PC0003/23 Farm Rd. ADC Comments on DO Ltd Stormwater RFI Response

CONISTON PARK LIMITED
FARM ROAD SUBDIVISION - PROPOSED PLAN CHANGE

CROSS SECTION - OUTLINE DEVELOPMENT PLAN

Figure 1- K37/2568: less than 200m north of the site. 3m to gravels

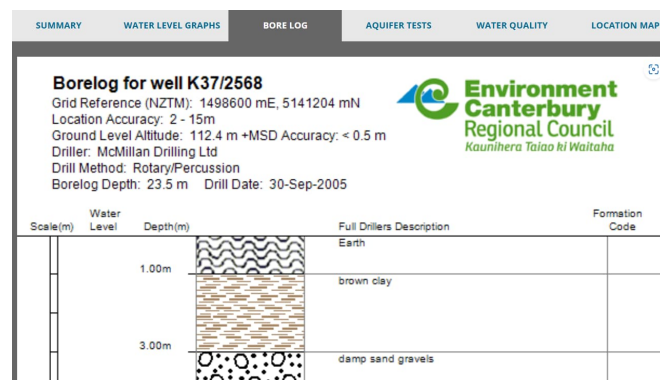
The depth to free draining gravel varies as shown of the following two nearby bore logs.

Based on bore logs, your comment and the test pitting/infiltration tests of 2023 we conclude that the free draining layer is between 1.5m and 3m below existing ground level across the site, rather than the assumed depth of 1.5m. This means that the excavation to free draining gravels for the infiltration systems will need to be deeper than 1.5m below existing ground to match.

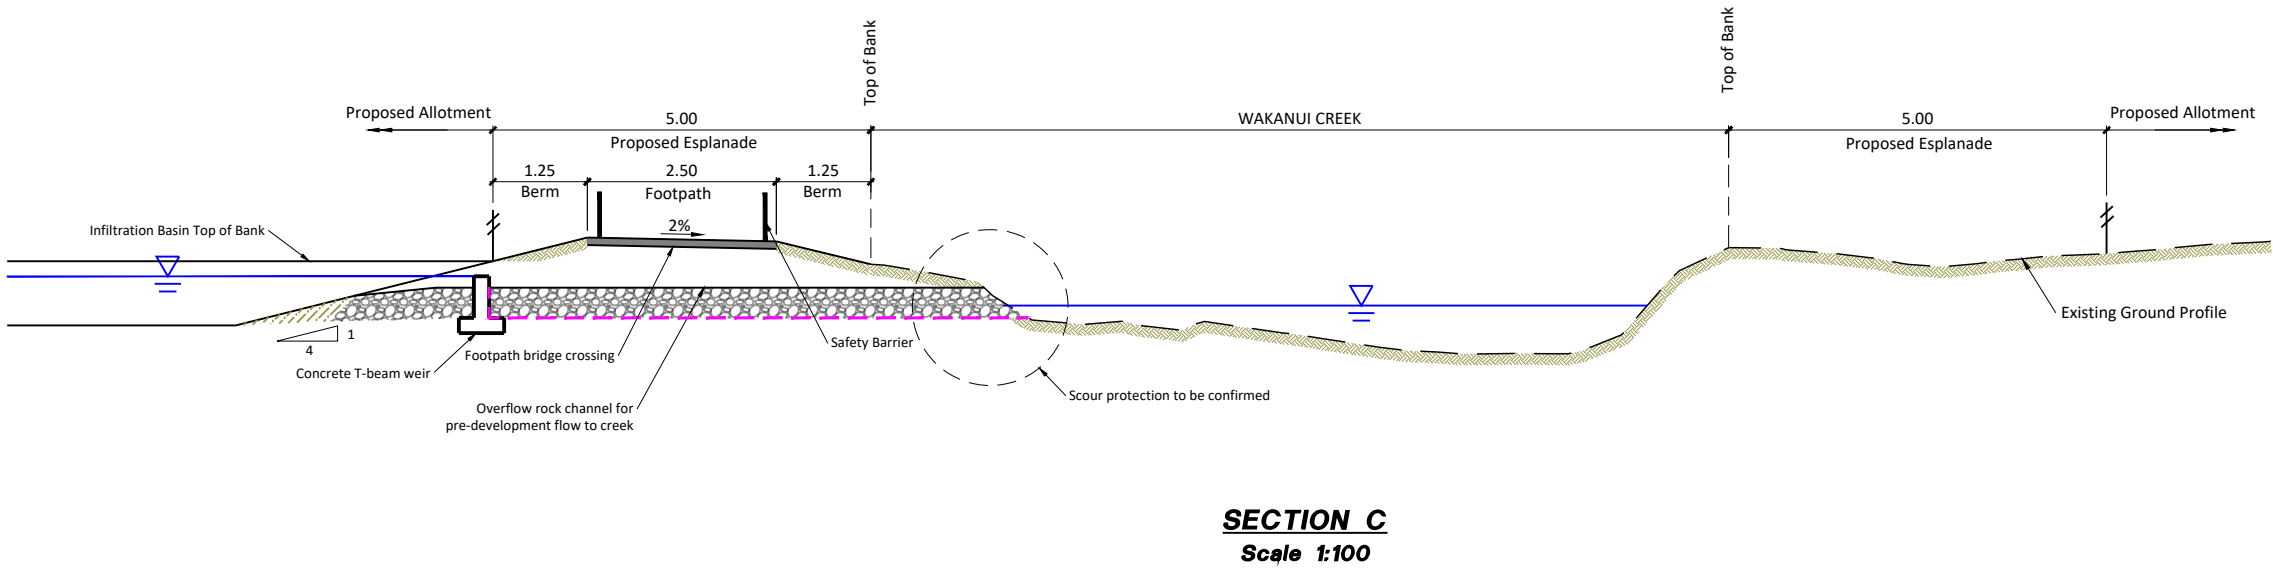
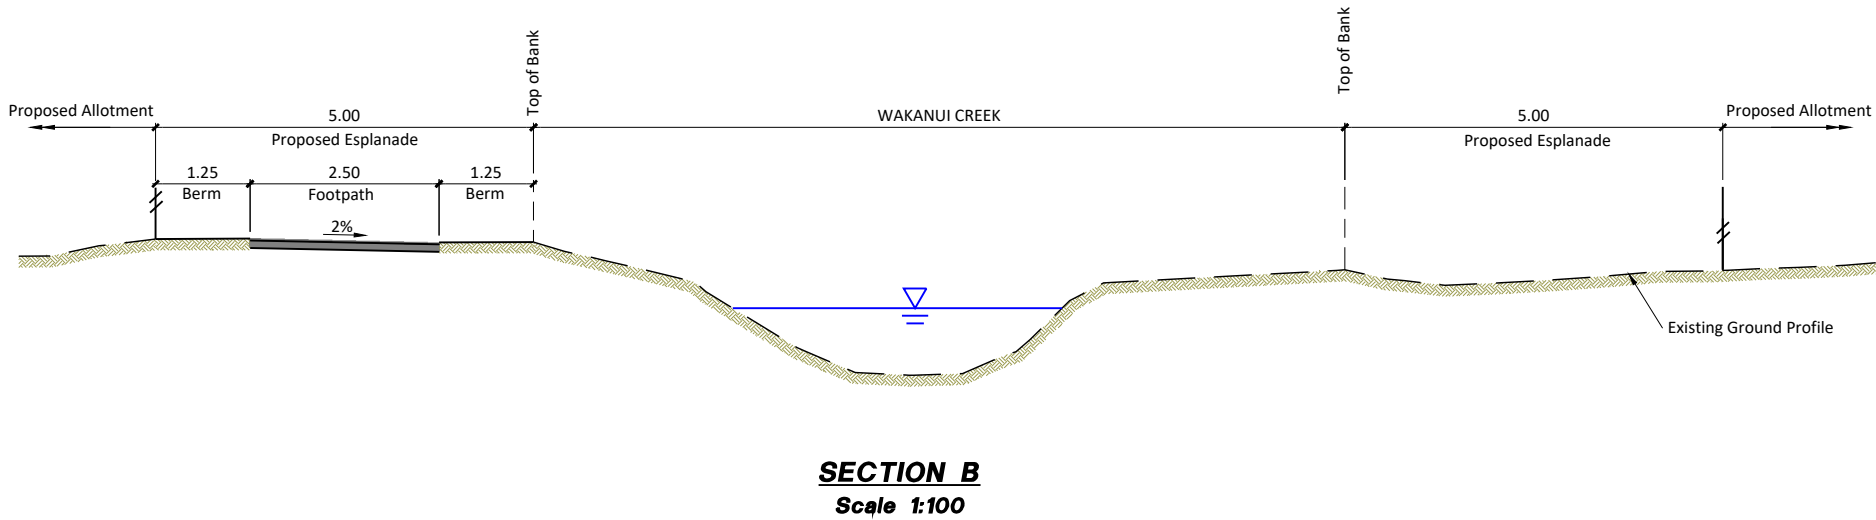
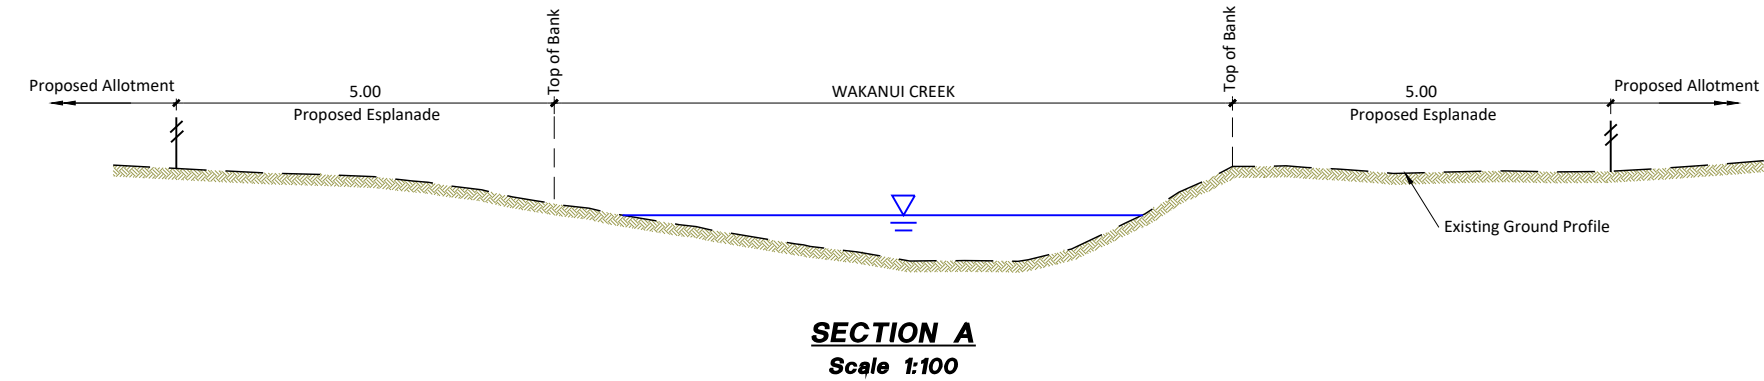
Soakage to ground is not suitable at this site because of the relationship between depth to suitable gravels and high groundwater, as discussed in the following section.

ADC will not allow the base of either pond to intercept GW, no matter how infrequently it occurs, as that would require a 'groundwater take'. If this is required, you would need approval from Ecan for both the infiltration of stormwater to GW and a GW take. In the case of stormwater discharge, the ADC global stormwater consent would not be available to authorise stormwater from this site.

The Ecan Land and Water Regional Plan rules related to discharge to land specify a separation of 1m from the seasonal high groundwater level. ADC sometimes allows global consent users to reduce the separation between the highest recorded ground level. In this case there is no separation between the highest recorded GW level.

This includes an updated Outline Development Plan (ODP), revised in response to ADC's feedback to account for the 1% Annual Exceedance Probability (AEP) storm event and the assumption of no soakage to ground.

To accommodate this consideration, the proposed stormwater management area has been enlarged accordingly within the ODP. This area may be subject to further refinement during the Engineering Design and Approval phase, where opportunities to reduce its footprint will be assessed based on detailed modelling and design outcomes.

- OP01: Updated Plan Change ODP
- OP02 & OP03: Supporting cross-sections and additional technical information for Council submission

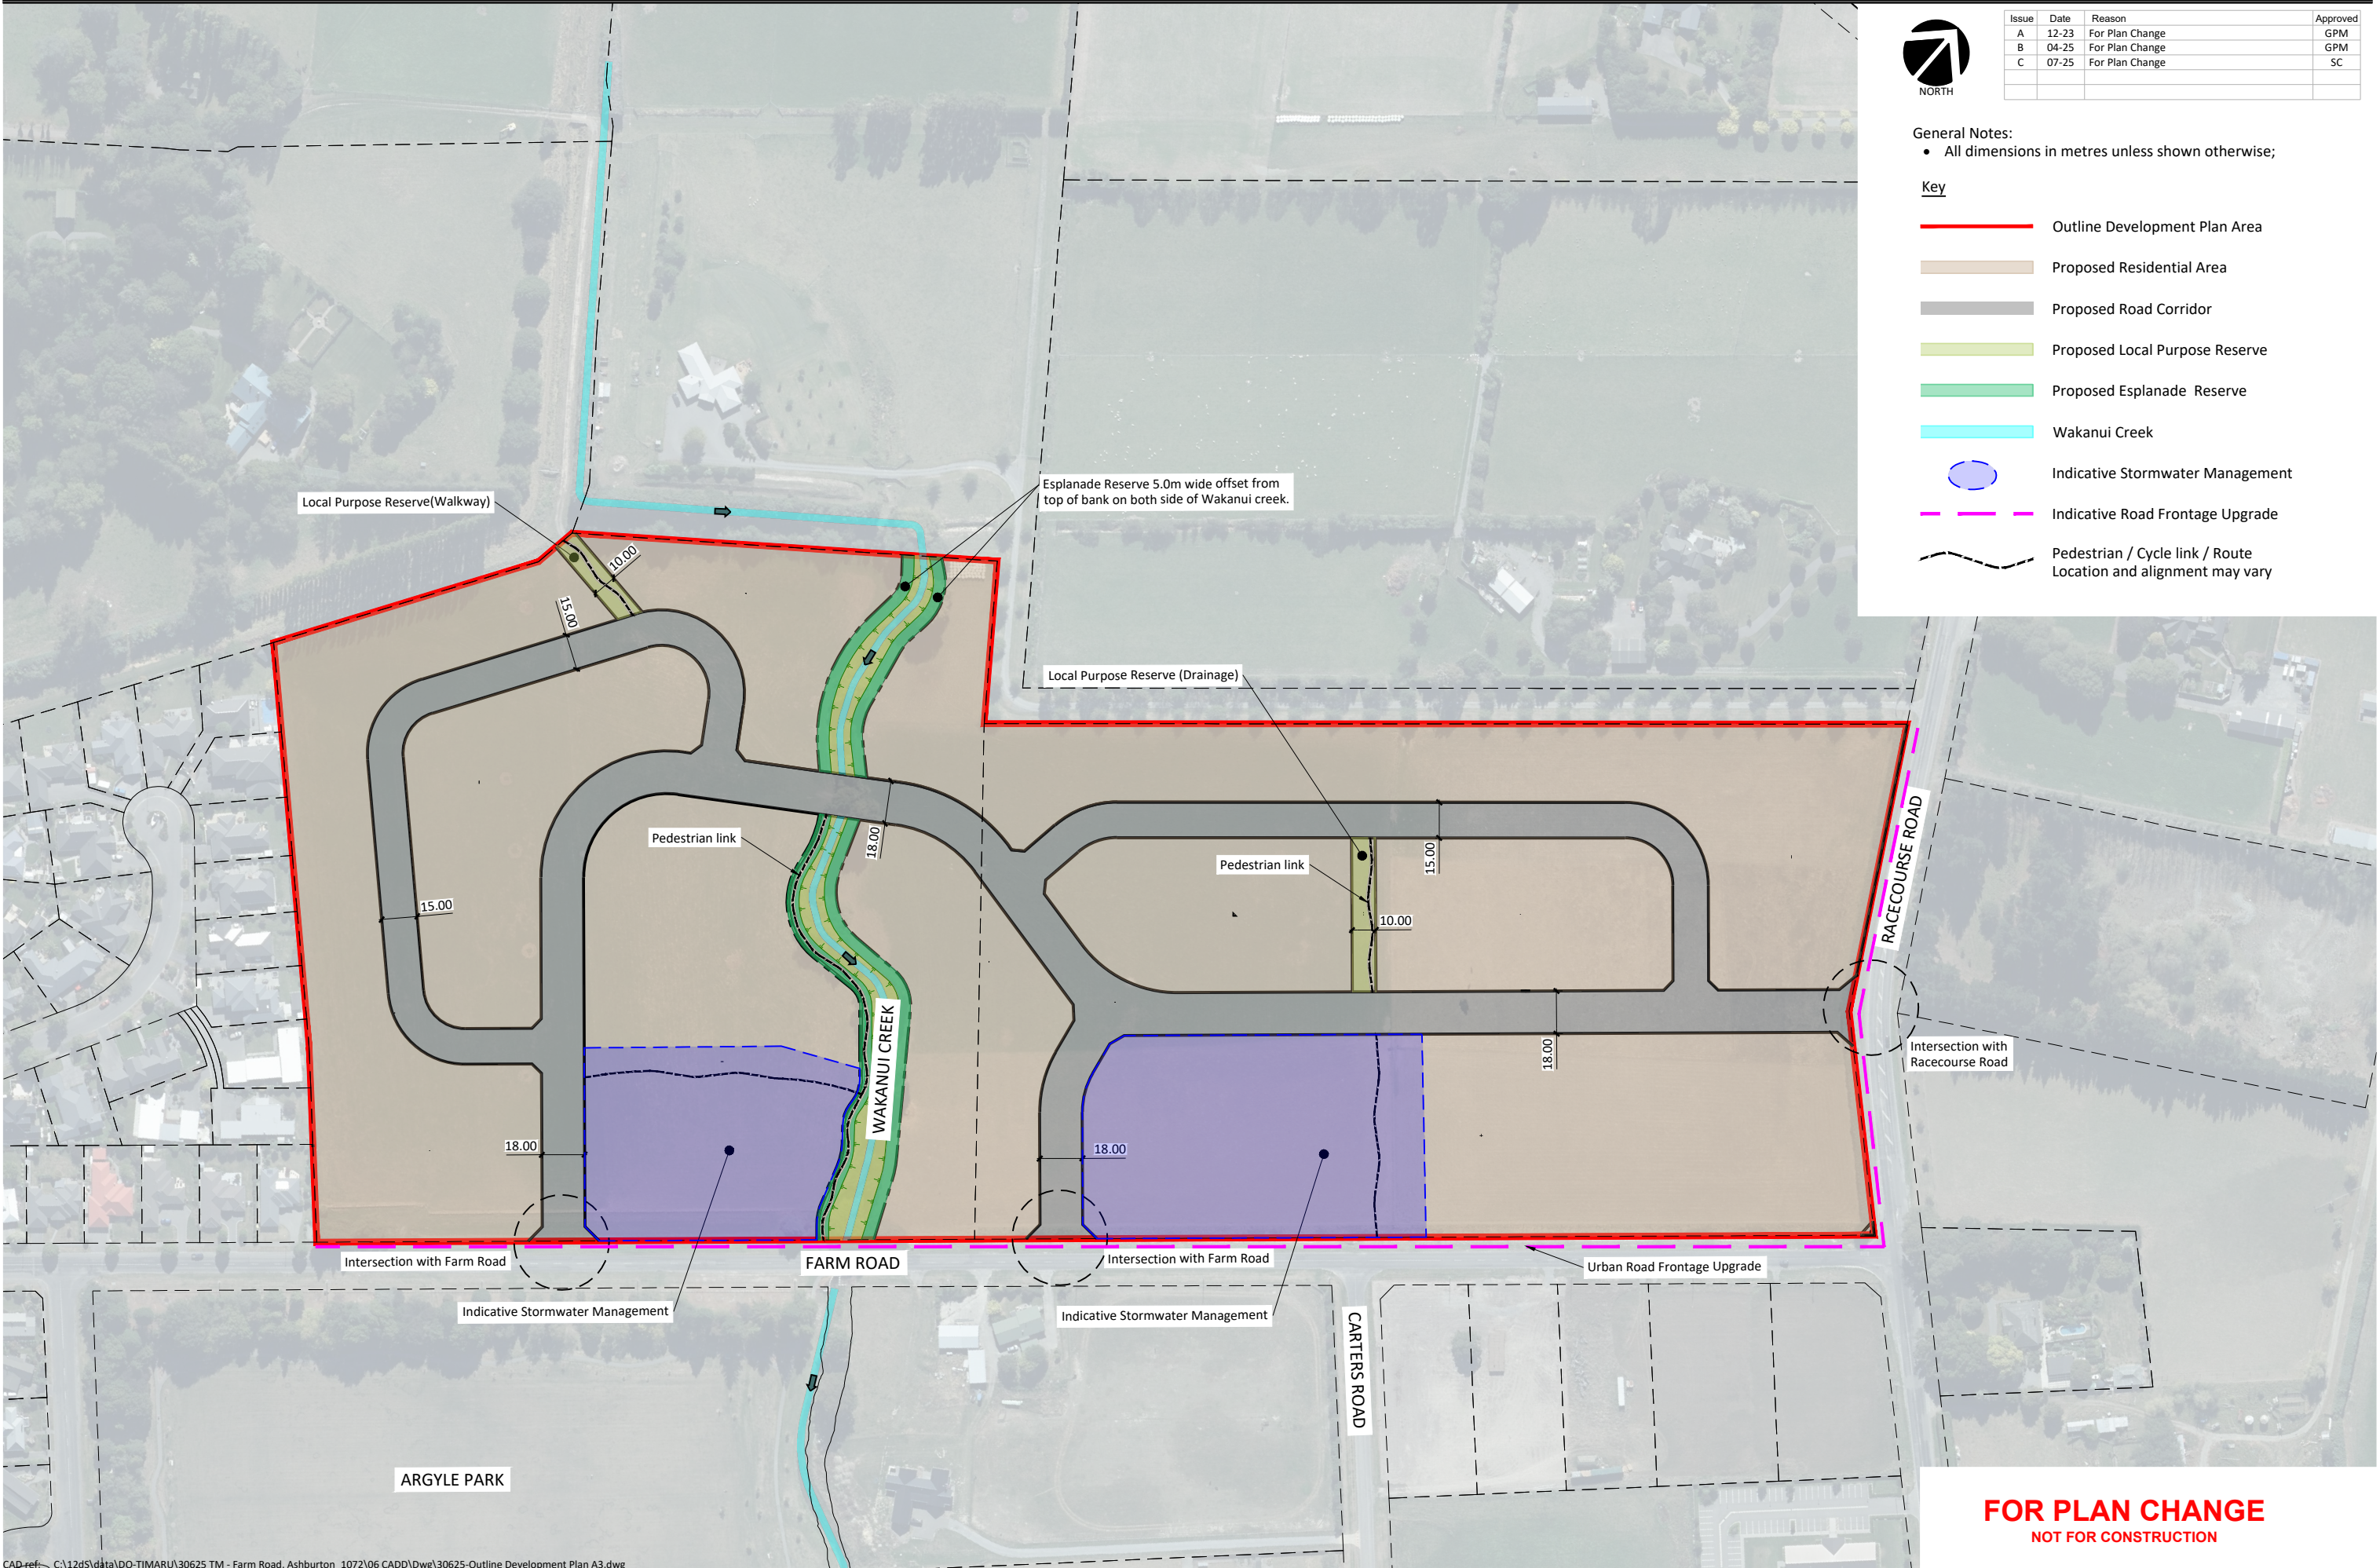
The stormwater management area (SMA) sizing calculations are based on 2% AEP with climate change (CC) allowance, but ADC require 1% AEP + CC.

Please provide updated calculations.
